Final authors response to Referee 2

Hydrological spatial coupling within an abandoned Mediterranean terraced microcatchment

MS No. egusphere-2026-2711

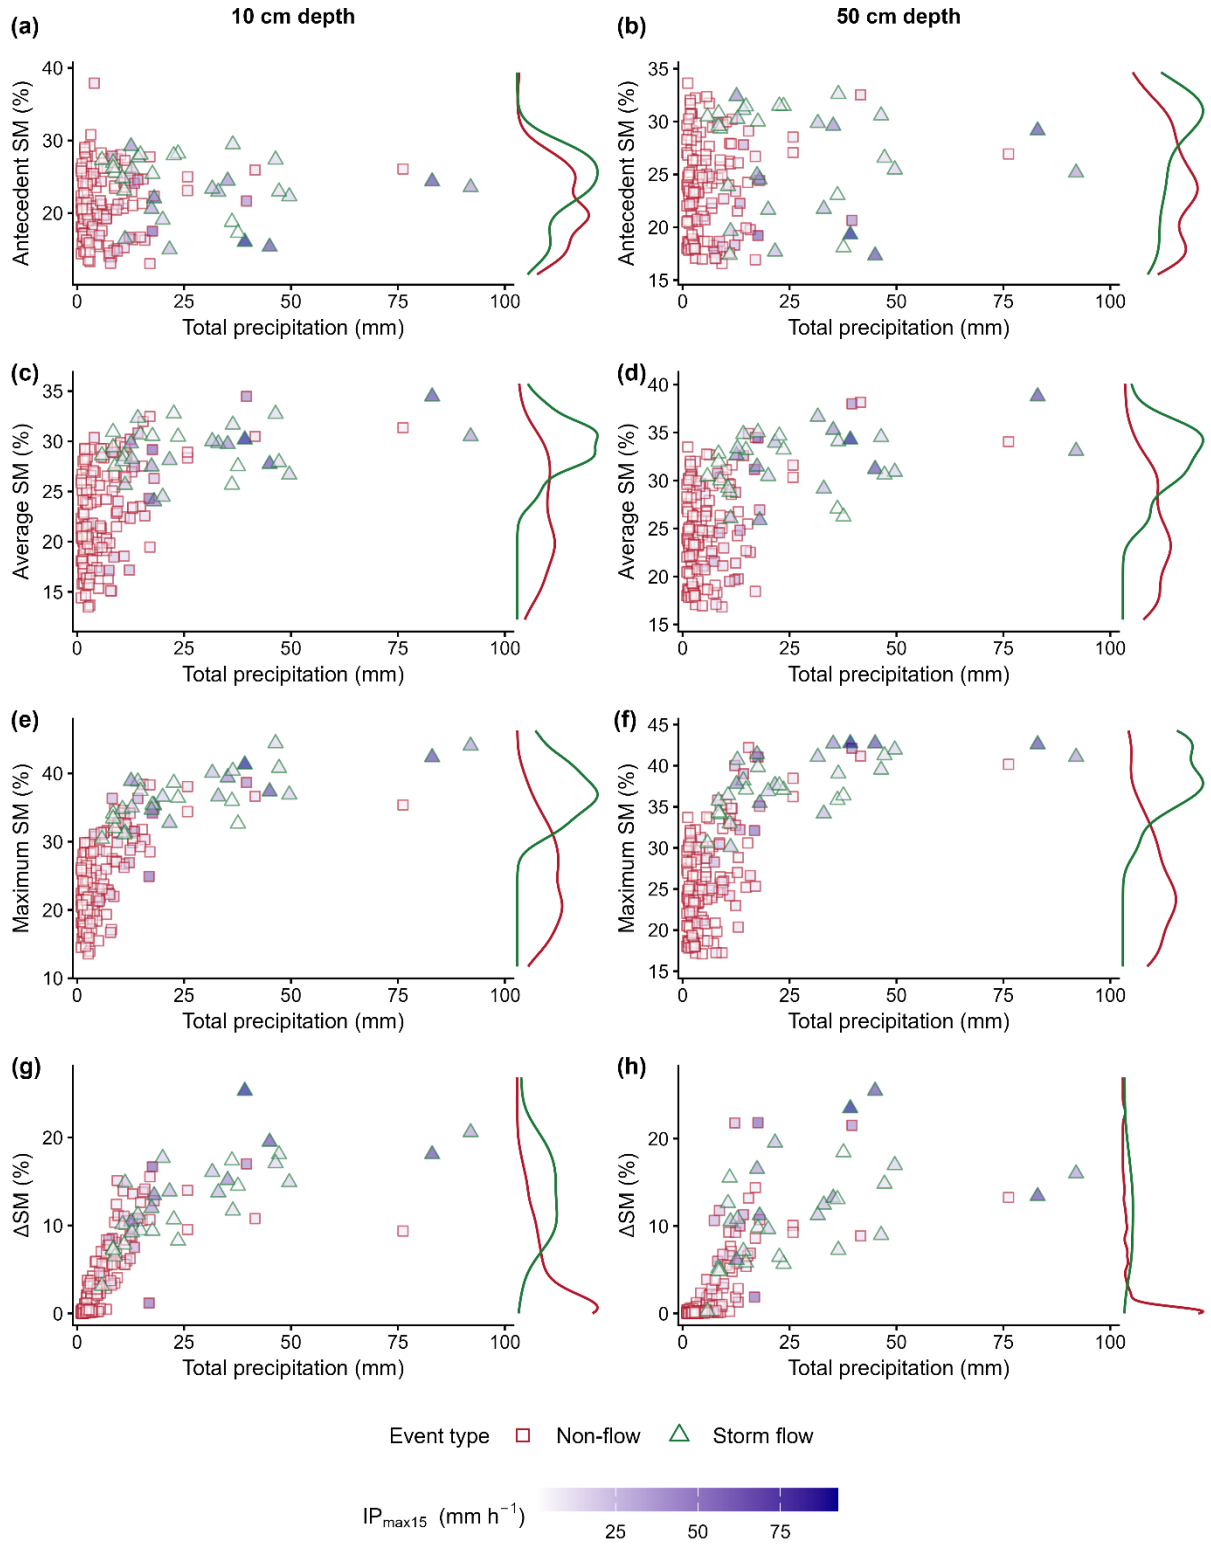
SC-R14 — Figure 5: the lettering is small, but the figure itself is very effective and summarises the core of the experiment well. It is notable that the change in SM discriminates more clearly at the deeper sensors than at the shallow ones, which is an interesting result and worth highlighting in the text. In the caption you note that symbol colour represents maximum 15-minute P intensity (IP_{max15}) for each event; this appears to be applied only to events with outlet flow. Extending it to non-flow events would be informative and would make the comparison more complete.

We thank the reviewer for this assessment of Fig. 5. We have increased the lettering and revised the figure to improve both readability and the representation of the storm-flow and non-flow event distributions.

Regarding the suggestion that ΔSM discriminates more clearly between event types at 50 cm than at 10 cm, we reassessed this pattern using the revised Fig. 5, which now includes class-specific marginal distributions. These distributions do not support a clearly stronger separation at 50 cm. Storm-flow and non-flow events show marked differences in ΔSM at both depths, but the degree of separation appears broadly comparable, with substantial within-class variability at both 10 and 50 cm. We therefore do not consider the visual pattern in the submitted figure sufficient evidence for a systematic depth-dependent difference in the degree of separation between event classes.

Regarding IP_{max15}, we would like to clarify that this variable was already represented for both storm-flow and non-flow events in the submitted Fig. 5. The original caption stated that symbol colour represented IP_{max15} for each precipitation event. No substantive change was therefore required in this respect.

The revised Fig. 5 is shown below and will replace the submitted version in the manuscript.
